#### **ADDENDUM NO. 1**

## PAVING OF ROSLAND RD: US 97 TO DRAFTER RD

## PLANS FOR PAVING OF ROSLAND RD: US 97 TO DRAFTER RD

Replace Sheet No. 3 of the Plans, titled "TYPICAL SECTIONS", with the revised sheet, which is attached hereto.

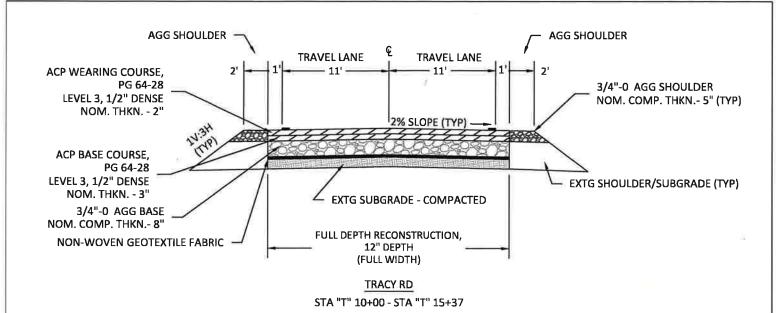
CHANGE TEMPORARY ROADBED SURFACING WIDTH AND DEPTH (04/12/2023)
